Proponent: Jay Crandell, ABTG/ARES, representing FSC

International Energy Conservation Code
Code Change Proposal Tracking Sheet

Proposal #	RED1260-22 Editorial revision
CDP ID #	.28 Tm-[k•

Carbon Rating Index Evaluation

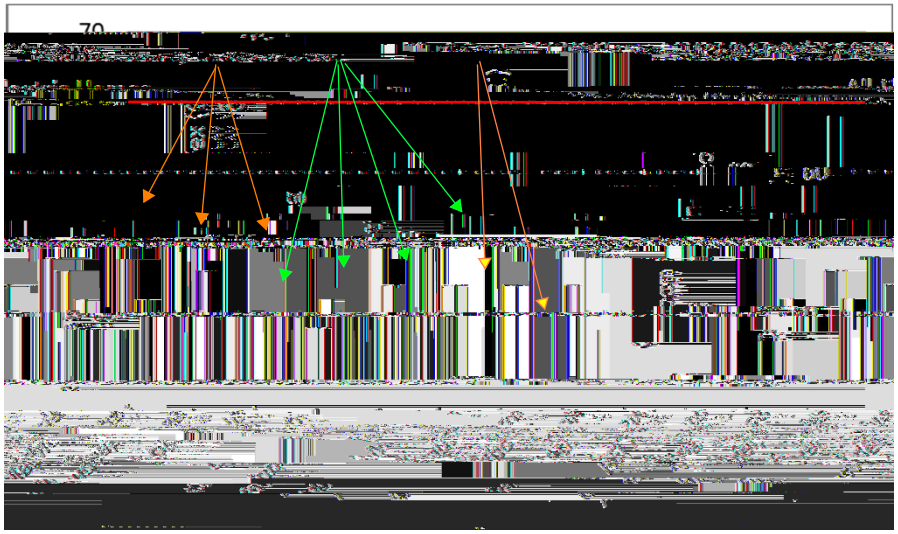
Sub-Committee was concerned that a maximum CO2e Index of 55 was too low for the Appendix and preferred to start with something more reasonable. 65 is shown below, in the context of the CRI's achieved by all-electric above-code homes.

ASHRAE 90.2 Home: Atlanta

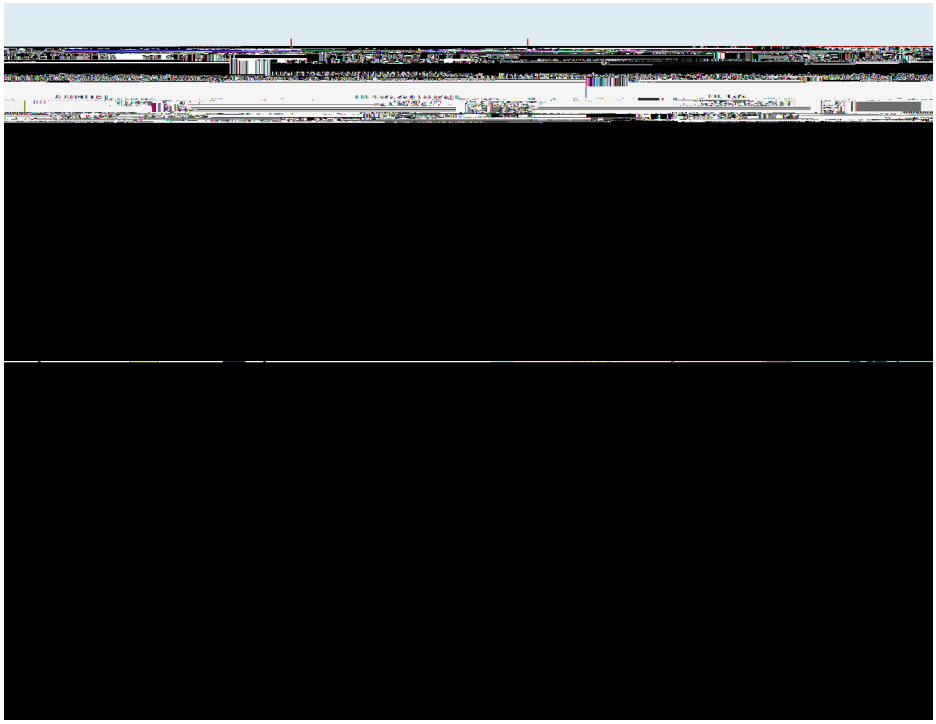
Sub-Committee expressed some concerns and questions about information provided on the label / certificate and whether it will cause confusion for homeowners.

Regardless of whether the rating is used for code compliance or not, all homeowners receive a certificate similar to below when an an energy rating is performed on their home in accordance with ANSI/RESNET/ICC 301, which lists ERI, CO2e Index, address, projected CO2e emissions, projected annual site energy, and projected annual energy costs.
